TECHNICAL EVALUATION REPORT

TUE-1 DEPARTURE FROM NUCLEATE BOILING CORRELATION

E.D. Hughes
W.C. Arcieri

SUBJECT: COMANCHE PEAK STEAM ELECTRIC STATION (CPSES)-UNIT 1
DOCKET NO. 50-445
REQUEST FOR ADDITIONAL INFORMATION ON RXE-88-102
"TUE-1 DEPARTURE FROM NUCLEATE BOILING CORRELATION"

FIGURE 1.

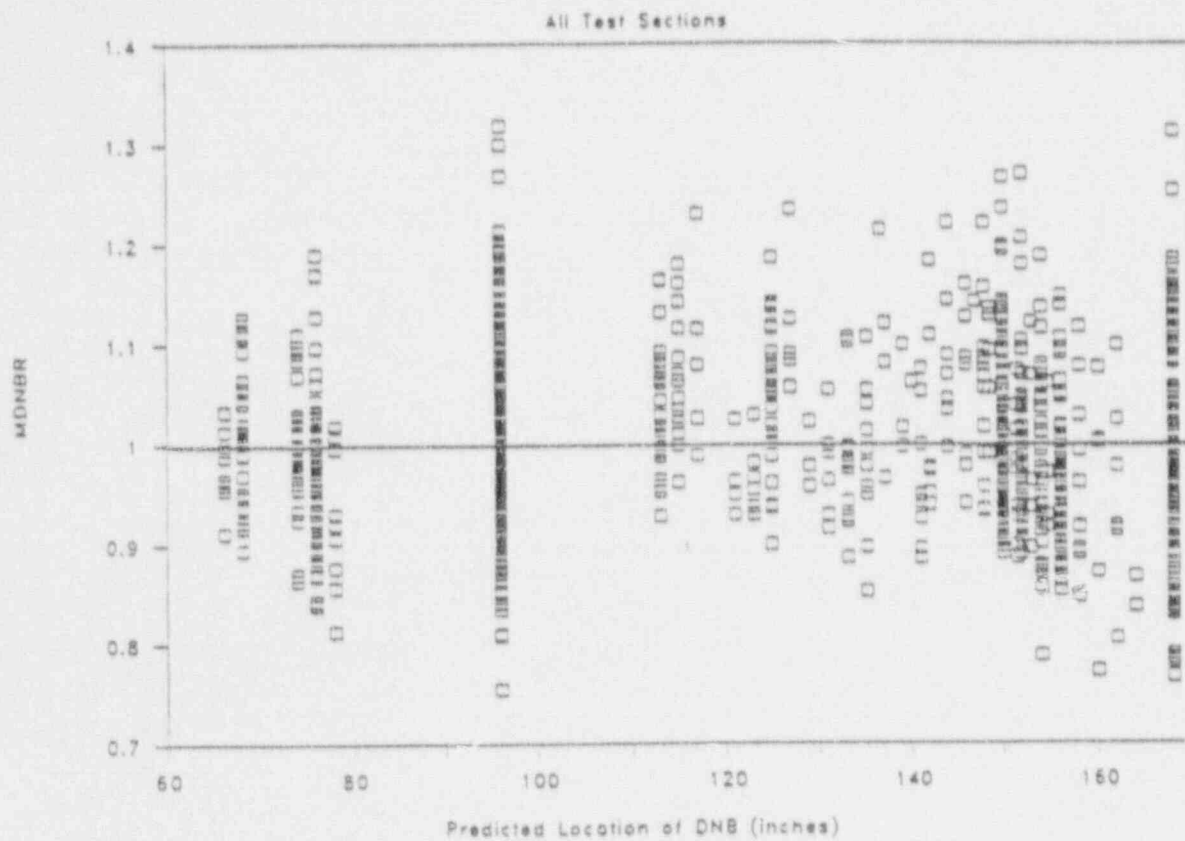
3. NRC Request: To make the table on page 2-5 [of RXE-88-102] complete, please identify the ranges for the following parameters: 1) fuel rod diameter, 2) thimble guide tube diameter, 3) rod pitch, 4) distance from inlet at which DNB occurred, and 5) enthalpy at the DNB location. Please also supply the inlet temperature for the tests.

The range of the distance to DNB over which the correlation is considered applicable is not limited to distances greater than 68 inches even though this represents the lower limit of the experimental data used in the correlation development. As Figure 1 (attached) shows, the behavior of the calculated MDNER exhibits no trend with changing distances to DNB. This behavior indicates that extrapolation below the 68" value is acceptable.

FIGURE 2.

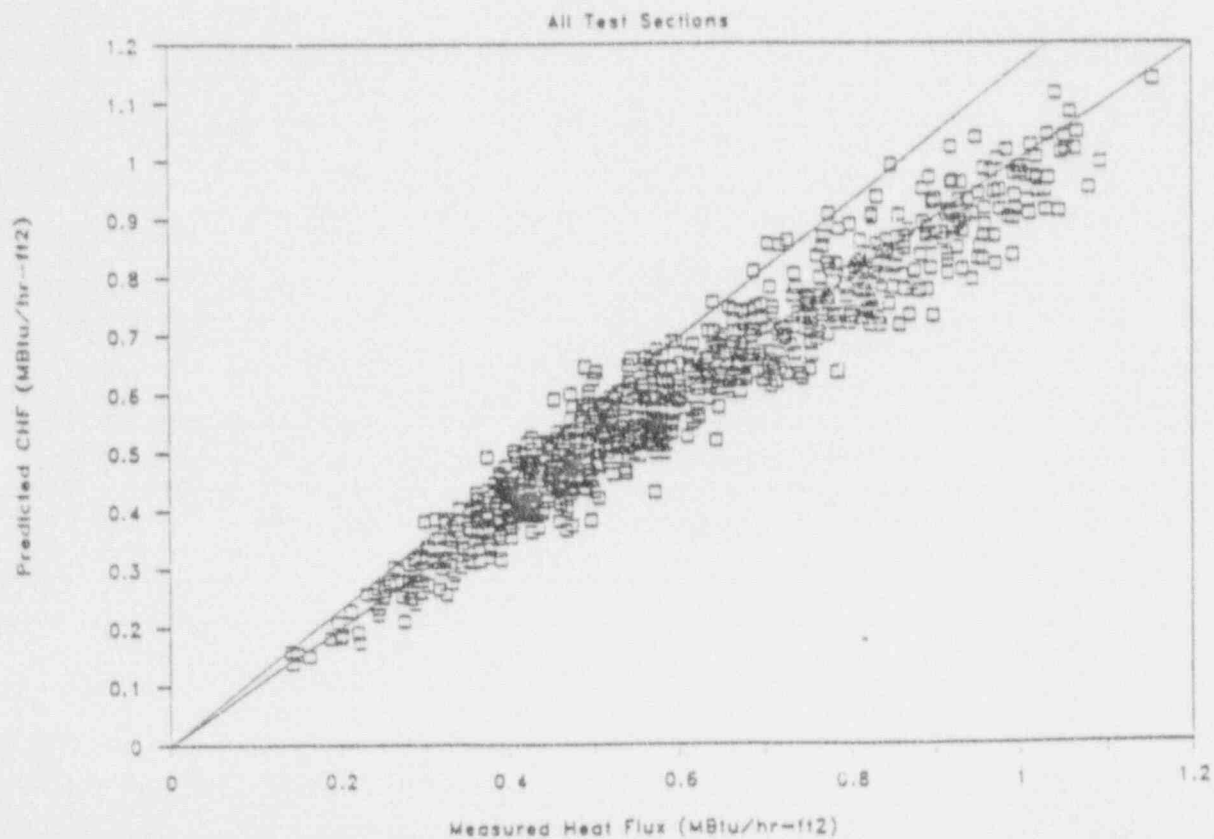
4. NRC Request: To allow for a more quantitative measure of the bias, please provide fits of QDNB predicted as a function of QDNB measured for each test section and for all data combined. The intercept of the fits should have the value 0.0, with a slope of 1.0.

TU Electric Response: The fits of QDNB predicted as a function of QDNB measured for all data combined and for each test section individually have been performed using linear regression. The results of the linear regression fits are summarized in Table 1. Plots of predicted CHF versus measured heat flux for all test data combined and for each test section are provided in Figures 2 through 21. Two lines are shown on each plot. The top line represents the locus of points corresponding to a MDNER of 1.16, which is the 95/95 limit for the TUE-1 DNB correlation. The other line represents the locus of points corresponding to a MDNER of 1.0.
